# MAYOR AND COUNCIL AGENDA

**SUBJECT:** Discussion and Instruction continued on Preliminary Development Plan application PDP2004-00007: To allow for a mixed-use development of office, residential and retail uses at the corner of Choke Cherry Road and Shady Grove Road (Upper Rock District); The JBG Companies, applicants.

## **Supplemental Staff Memorandum to Mayor and Council**

To: Deane Mellander  
 From: Matthew Hurson  
 Date: February 11, 2005  
 Re: PDP 2004 - 0007  
 Upper Rock District

View of Landscaped Art Wall from I-270 ramp

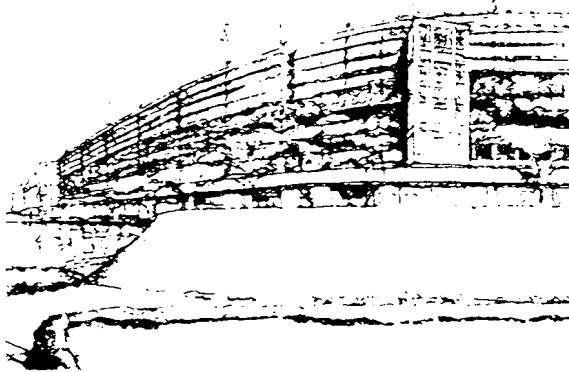
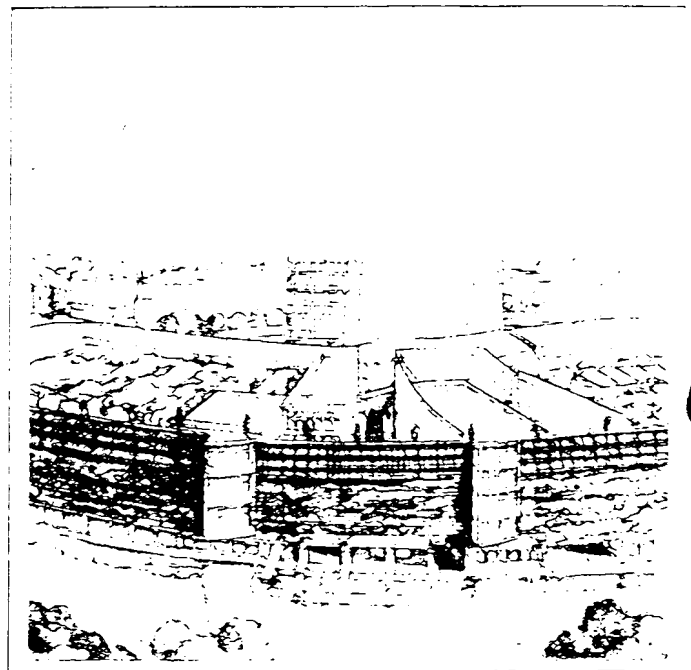
The Landscaped Screen Wall. We have examined the request that the wall be relocated to the outer edge of the property and concluded the location of the wall should remain where proposed.

- The wall serves as a screen to the parking structures and therefore must remain attached to the buildings.
- We agree that the experience of the wall from inside the community must be carefully considered. Creations of openings from inside the wall to the outside public spaces are an opportunity for a very exciting architectural experience.
- The applicant commits to establishing a community-oriented process (a "mini-Charrette") to gain input and support from the community at-large as a condition of Use Permit approval.
- Together with design approval, the applicant will prepare and submit draft covenants assuring continual, private maintenance of the Landscaped Screen Wall. The covenants will be similar to those applicable to key landscape elements of other private communities.

Details of the design of the wall, including the construction materials, art content, maintenance, etc. will be addressed at the Use Permit stage.

# Section C

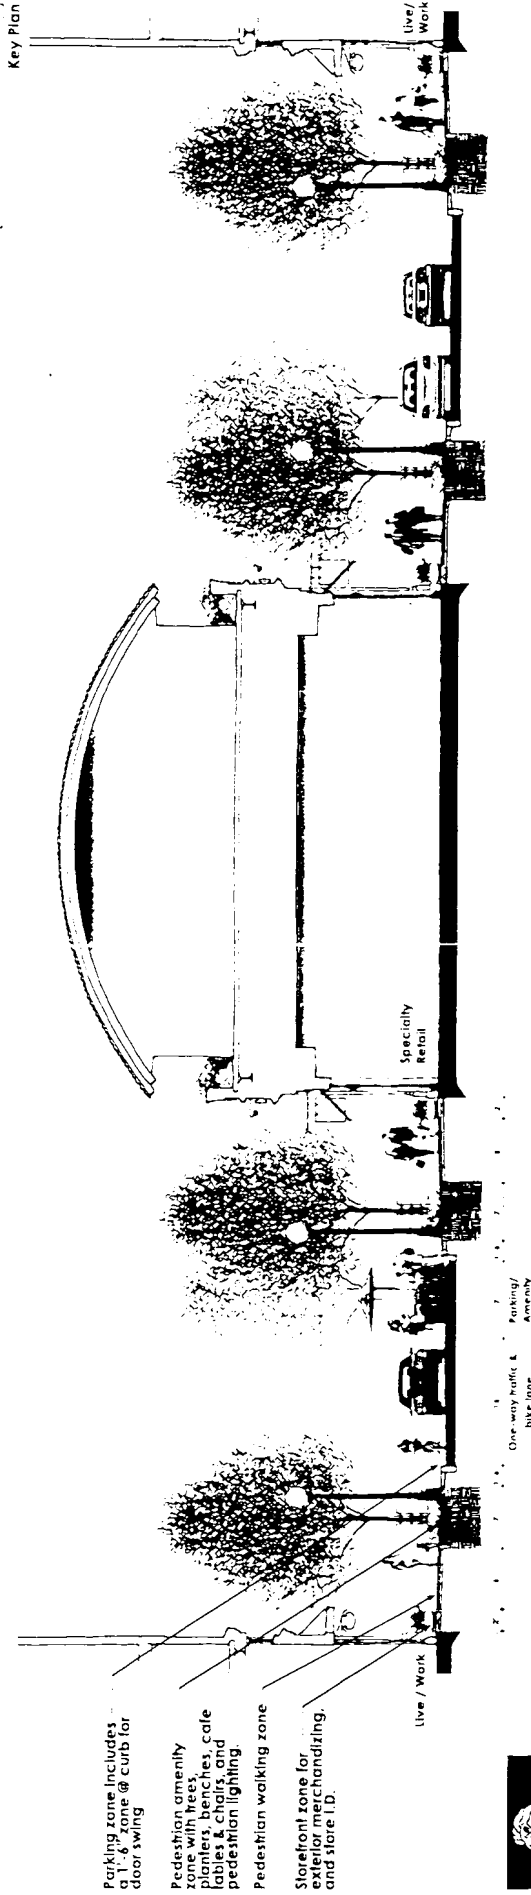
- Specialty Retail Market at Block D: See proposed Section C prepared by Street-Works, LLC. The sidewalk at the retail building will include 25'6" comprised of 18'6" of pedestrian walk plus a convertible 7' parking lane.
- Choke Cherry Road: See proposed Section E prepared by Street-Works, LLC. The sidewalk at the residential/live-work units along Choke Cherry Road (Blocks B, C and E) shall not be less than 25'.
- Shady Grove Road: See proposed Section C prepared by Street-Works, LLC. The sidewalk will include design elements derived from the Rockville Pike Streetscape revised details and will include an 8' shared pedestrian/biker path separated from Shady Grove Road by landscaped berm.
